AURIX™ TC37x errata sheet

Marking/Step: (E)ES-AA, AA

About this document

Figure 1 Message buffer transfer from Message RAM to OBF

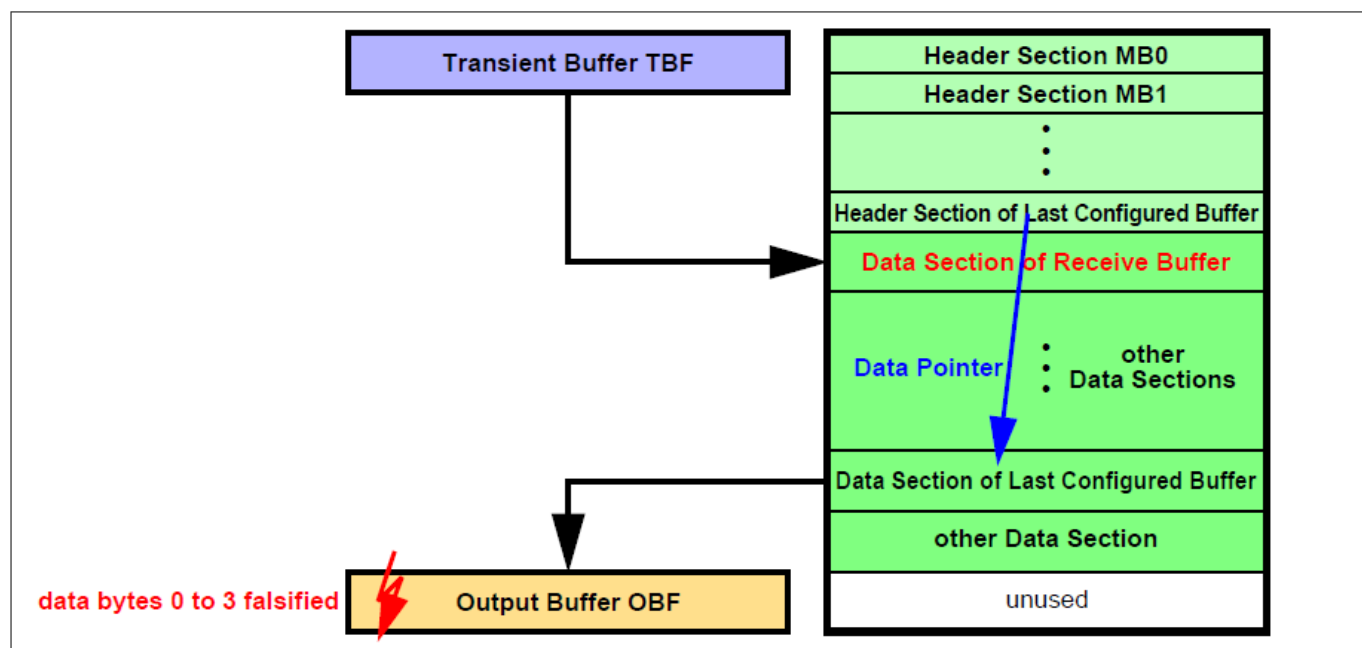
When the message buffer has its payload configured to maximum length (PLC = 127), the OBF word on address 00h (payload data bytes 0 to 3) is overwritten with unexpected data at the end of the transfer.

a) When a message is transferred from the Last Configured Buffer in the Message RAM to the OBF and PLC = 127 it may happen, that at the end of the transfer the OBF word on address 00h (payload data bytes 0 to 3) is overwritten with unexpected data (see [Figure 1](#))

Ensure that the Data Section directly following the Header Partition is assigned to a transmit buffer.

Figure 2 Message buffer transfer from IBF to Message RAM

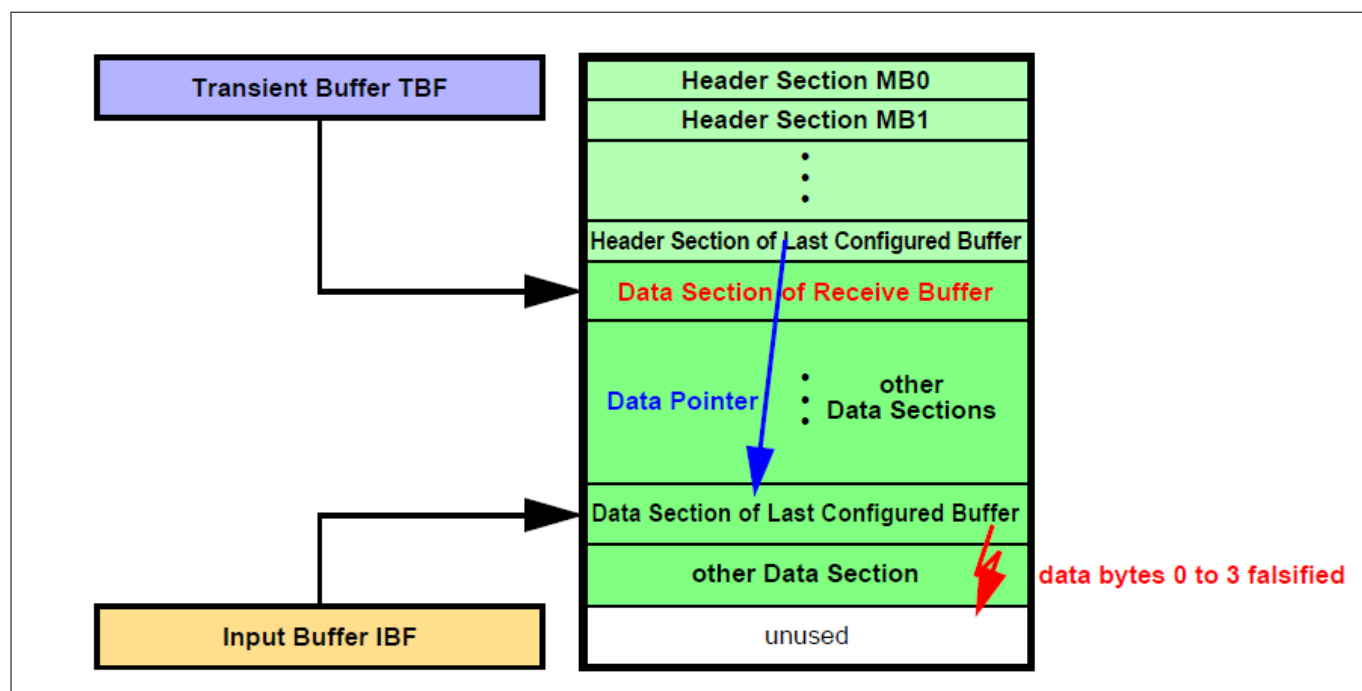
After the Data Section of the selected message buffer in the Message RAM has been written, one additional write access overwrites the following word in the Message RAM which might be the first word of the next Data Section.

b) When a message is transferred from IBF to the Last Configured Buffer in the Message RAM, it may happen, that at the end of the transfer of the Data Section one additional write access overwrites the following word, which may be the first word of another message's Data Section in the Message RAM (see [Figure 2](#))

Figure 3 Message RAM configurations

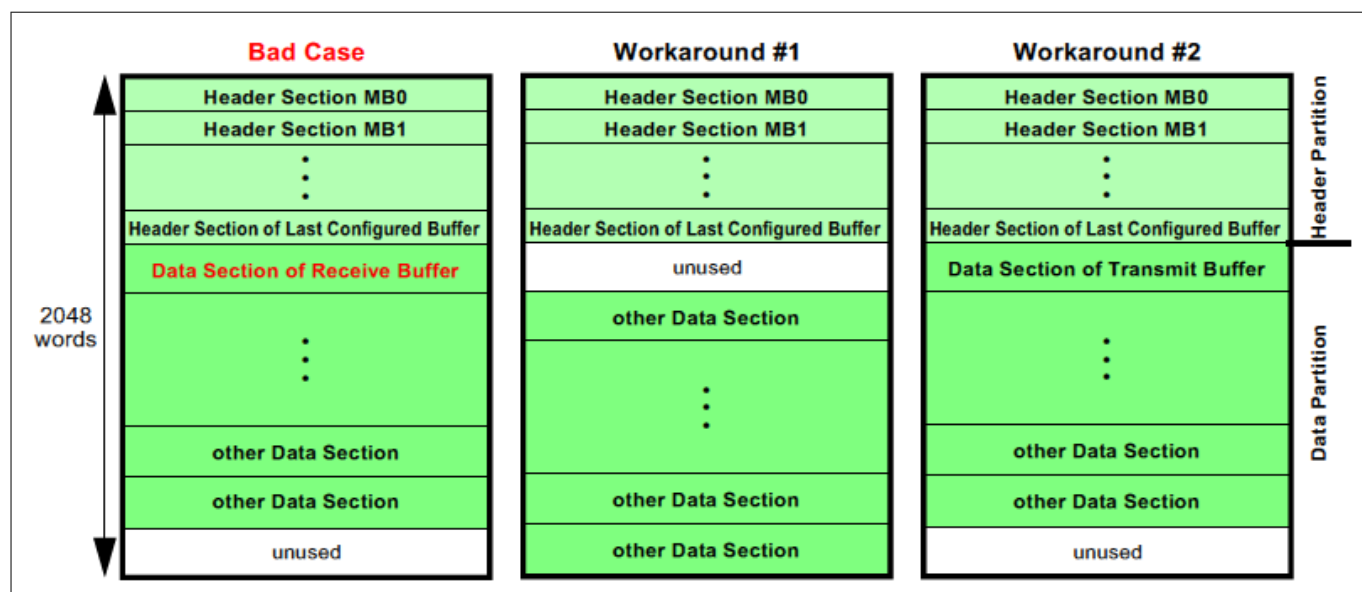
The erratum is limited to the case when (see [Figure 3](#) “Bad Case”):

Figure 5 MCS AEI master access path

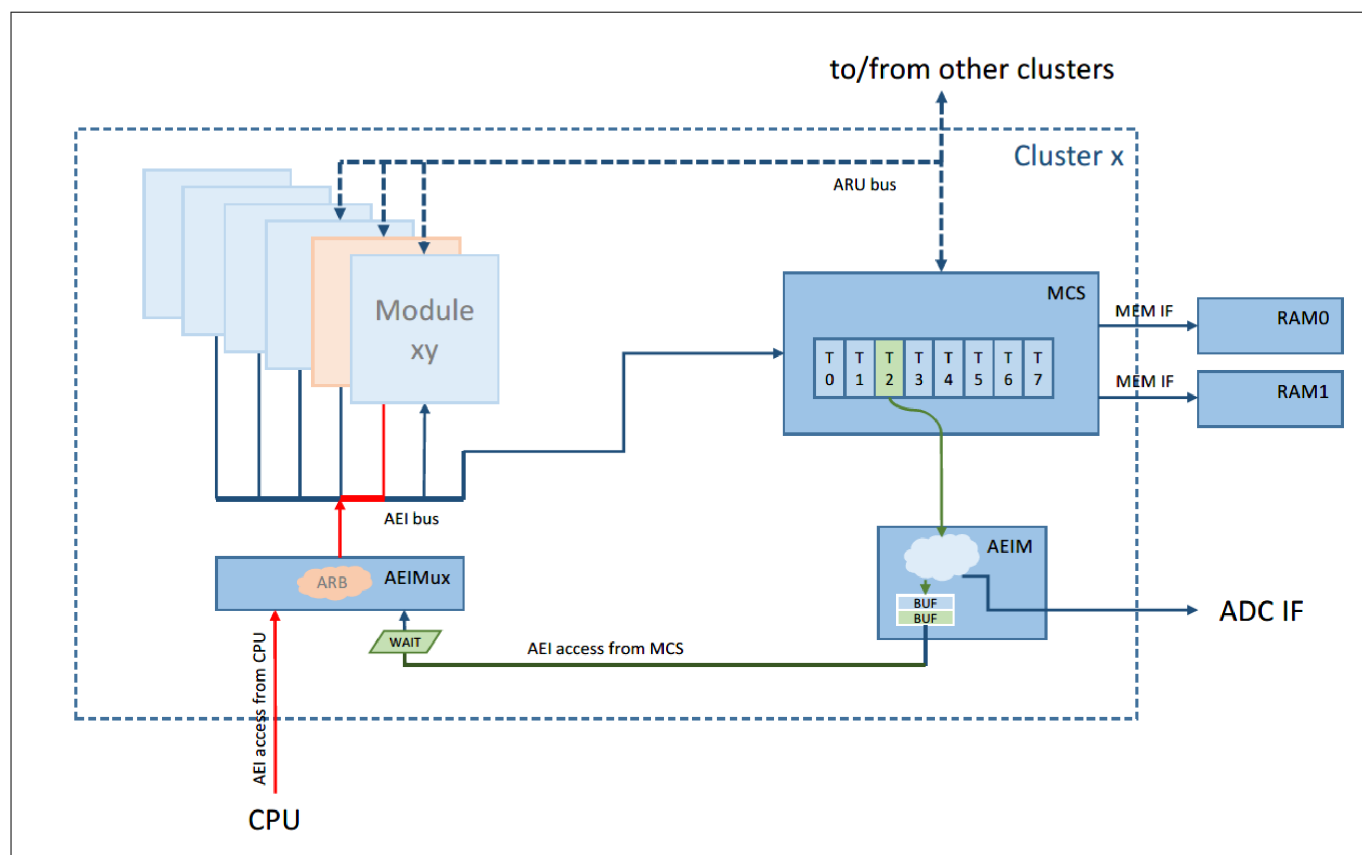
As accesses to ADC from MCS point of view are not different from AEI bus accesses, these ADC accesses are forwarded to the AEIM in the same way and on the same interfaces as MCS accesses to the AEI bus. The AEIM will identify the ADC accesses by their targeted address space and forward them to the GTM external ADC. As ADC accesses will always be served with zero wait time, these ADC accesses are not routed through the AEIM buffers.

To ensure that a correct execution of MCS channel code is not influenced by certain traffic scenarios on the MCS AEI/ADC bus master interface, only proven usage scenarios are allowed for MCS to AEI/ADC communication. The most common usage scenarios tested to be safe include:

Figure 6 Critical MCS AEI master scenario

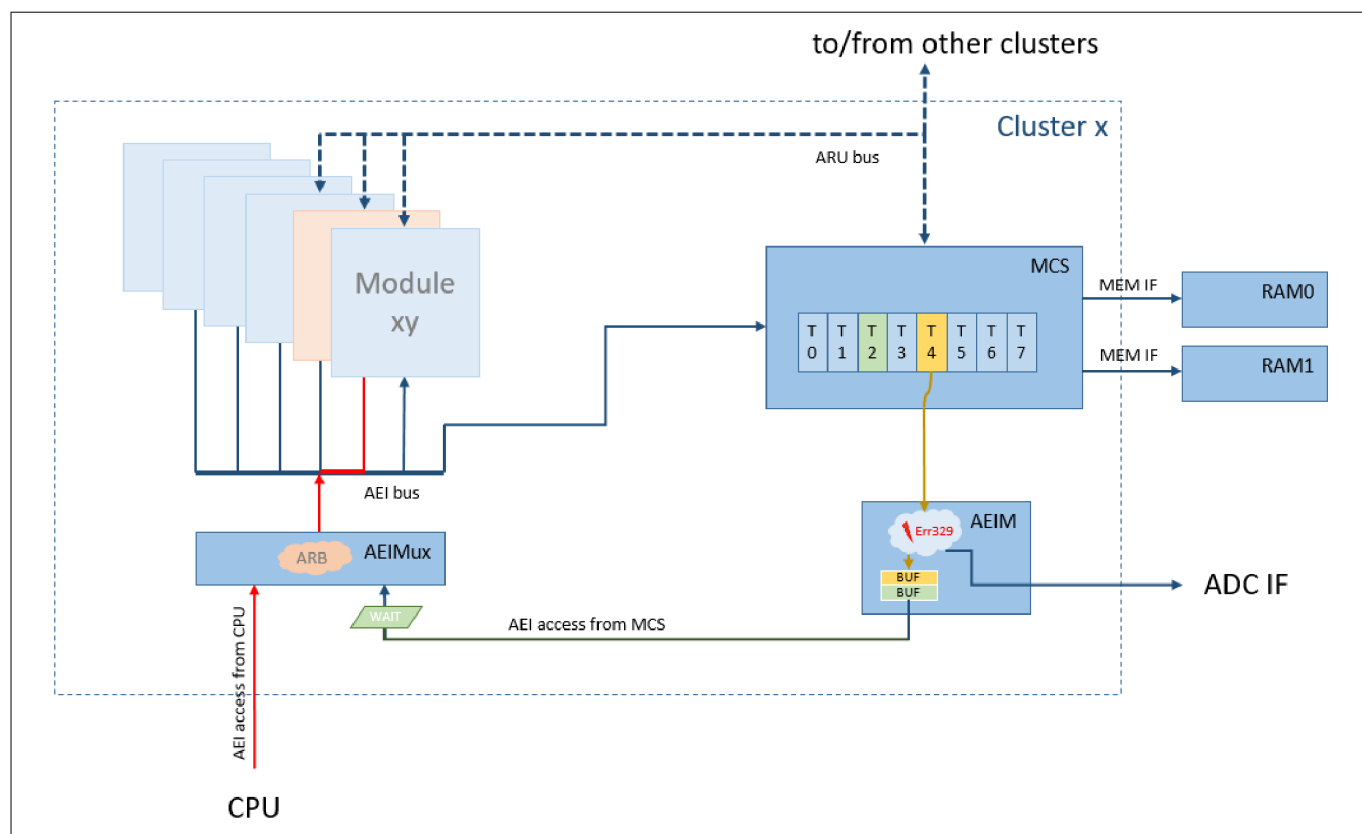
In [Figure 6](#), a potential risk for the occurrence of problem GTM_AI.329 is illustrated. Here the first buffer of the AEIM (green) is still waiting for the access to the AEI bus while a second AEI bus access from MCS arrives at the AEIM (yellow access path). Under certain, but for the user unpredictable timing conditions, this second AEI bus access arriving at the AEIM can trigger the misbehavior described in problem GTM_AI.329.

The workarounds described in the 'Workaround' section will ensure that not more than one AEIM buffer will be filled and therefore the occurrence of problem GTM_AI.329 is avoided. All workarounds have been tested and proven correct.

Figure 7 MCS token mechanism

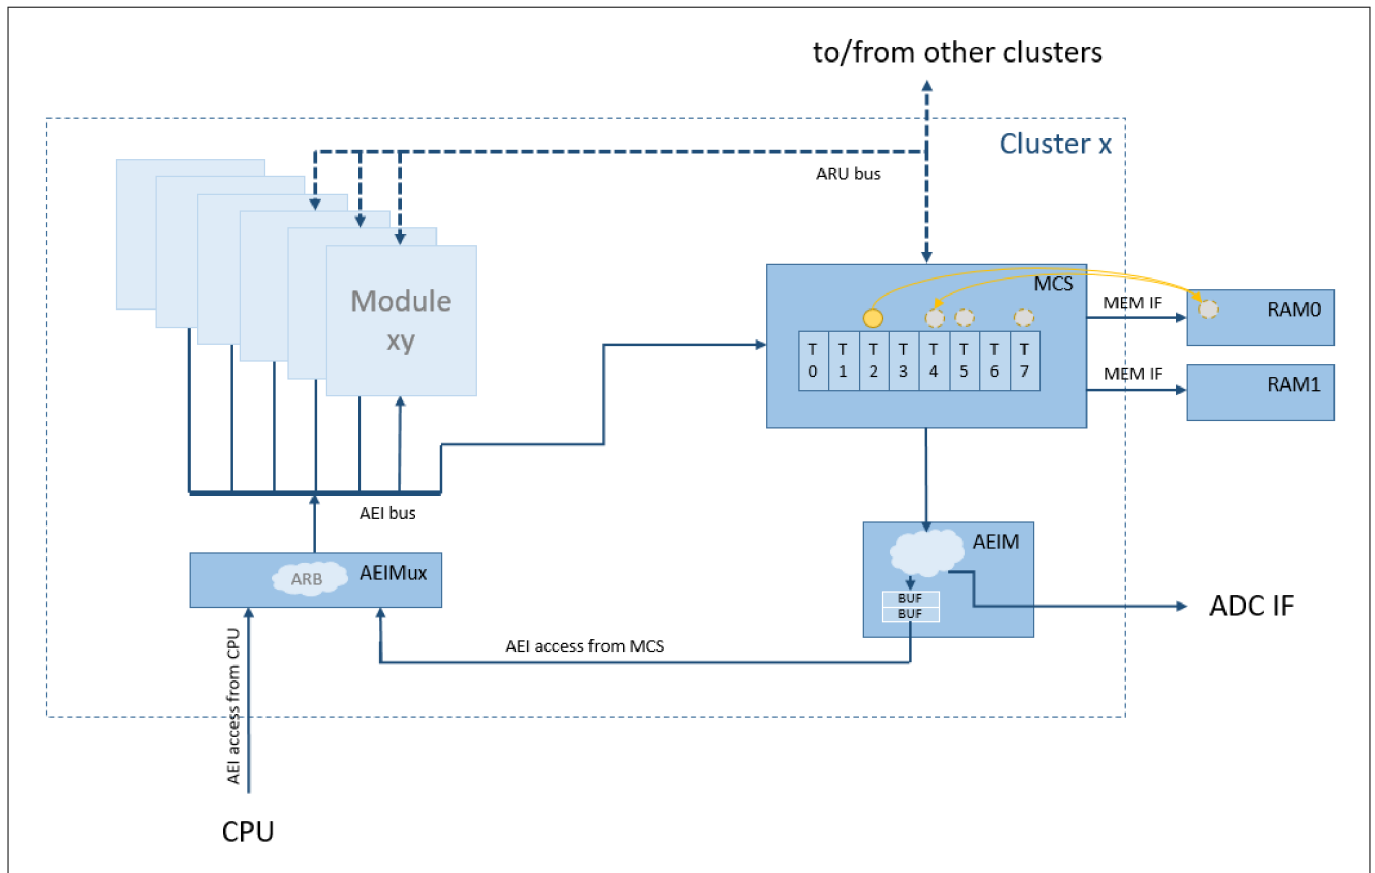
In case multiple MCS channels want to use the AEI master port for AEI or ADC communication, establish a mechanism that ensures that only one channel uses the AEI master at a time (e.g. exchange a token between channels or use trigger registers to hand over the AEI master port ownership between MCS channels).

An application note (AN020 – MCS Mutex implementation) describing a token exchange mechanism between MCS threads is available at Bosch. Such a token mechanism allows multiple MCS threads to safely access the AEI bus system by exchanging an AEI bus access token via MCS memory.

Figure 10 CAN Frame with DLC > 4

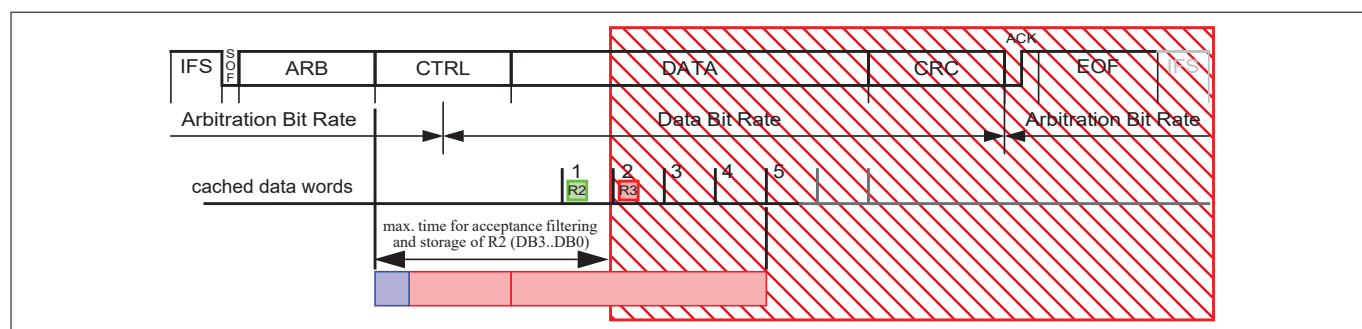
The figure that follows shows how the available time for acceptance filtering and storage is reduced.

Figure 11 Interrupt Level vs. Pulse-Notify mode - Corner Case Example

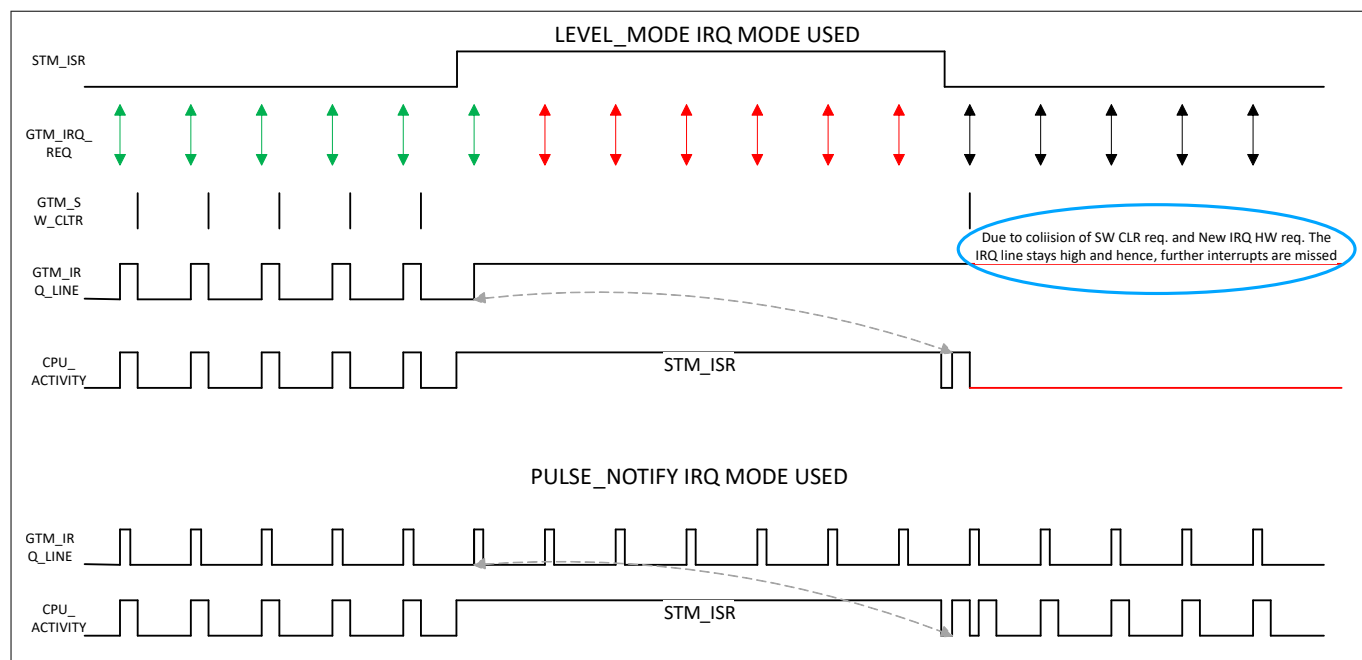
As described in the text below this figure, while using Level mode, if more internal “interrupt” events are generated (i.e. two TOM channels generating a CCU0 interrupt), just one interrupt signal is sent to the IR, and no more interrupts are triggered until the SW clears the GTM_IRQ_XXX line towards the IR.

Hence, in Level Mode, in some scenarios where another interrupt request is generated by GTM while the ISR handle also requests a SW clear, then, as the interrupt event is dominant over the clear event (for simultaneous interrupt and clear events), GTM_IRQ_XXX is not cleared and remains high. As a consequence, the IR observes no transition on GTM_IRQ_XX. Thus, any forthcoming interrupt events in this scenario are lost as there is no chance to release the CPU IRQ when a collision happens as shown in Figure below.

If Pulse-Notify mode is selected, every internal trigger will be forwarded to the IR, irrespective of the time of occurrence and the clear event, as the pulse-notify leads to set and reset of GTM_IRQ_XXX as compared to only setting of the GTM_IRQ_XXX line in Level mode.

Figure 12 Timing of LVDS TX interface command sending in relation to IRQ.IFCFS

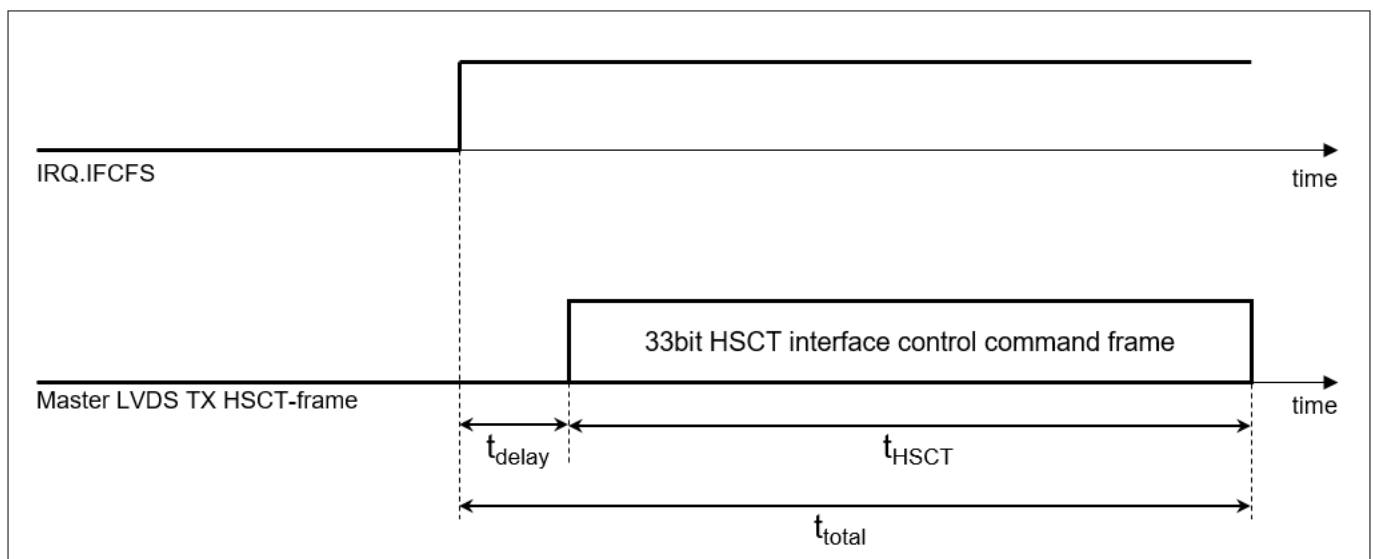
the user might falsely assume that also the actual sending on the LVDS TX port has already occurred once the IRQ.IFCFS flag is set, which is not true.

Instead the timing shown in the following figure applies.

Figure 13 Package Outlines LQFP-176 for TC37x

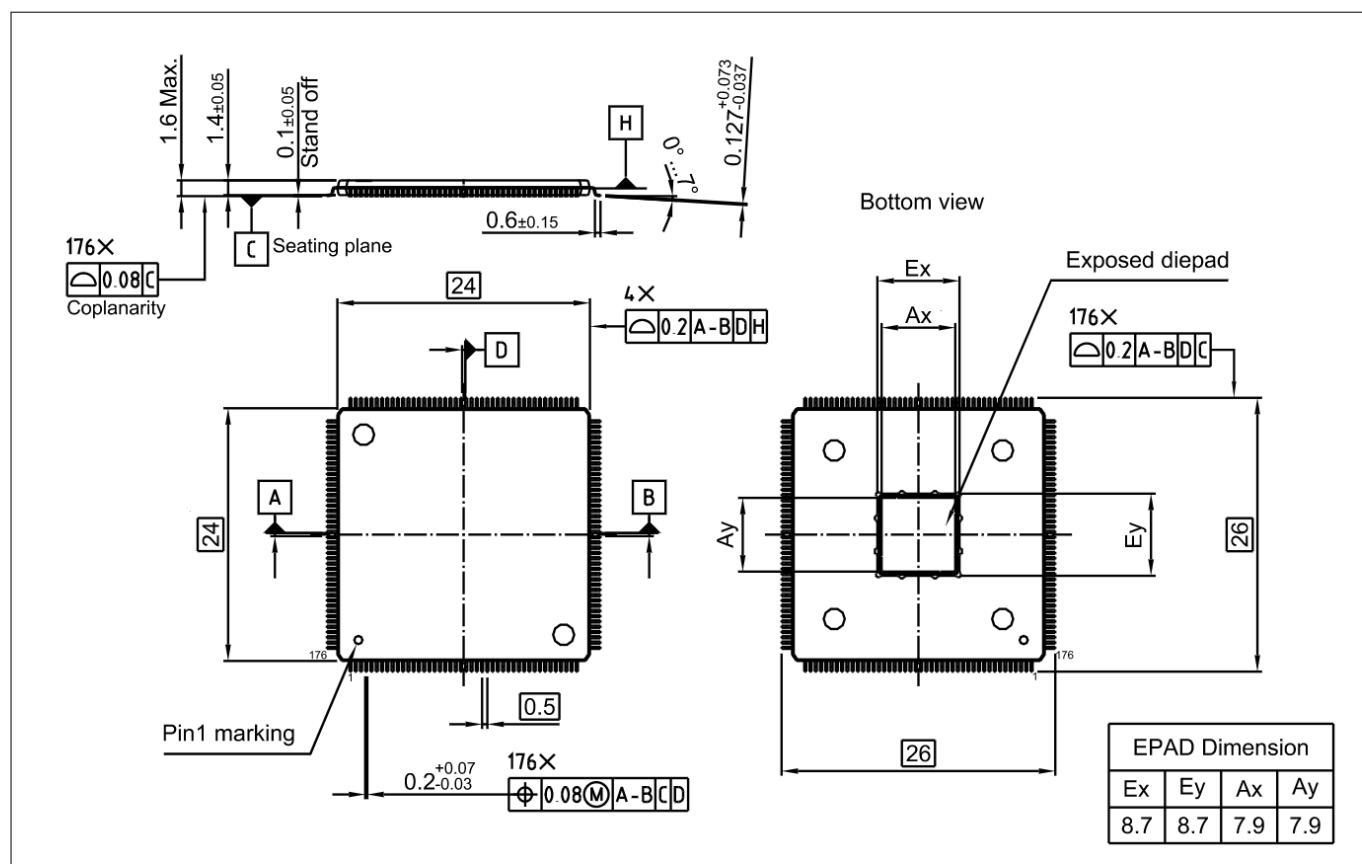
This information shall substitute the corresponding information in the TC37x AA-step Data Sheet V1.1.

Note: For the exposed diepad of the LQFP-176 package of the TC37x, structural corner protrusions have to be considered for purposes of system design and integration with a maximum boundary of 9.4 mm.
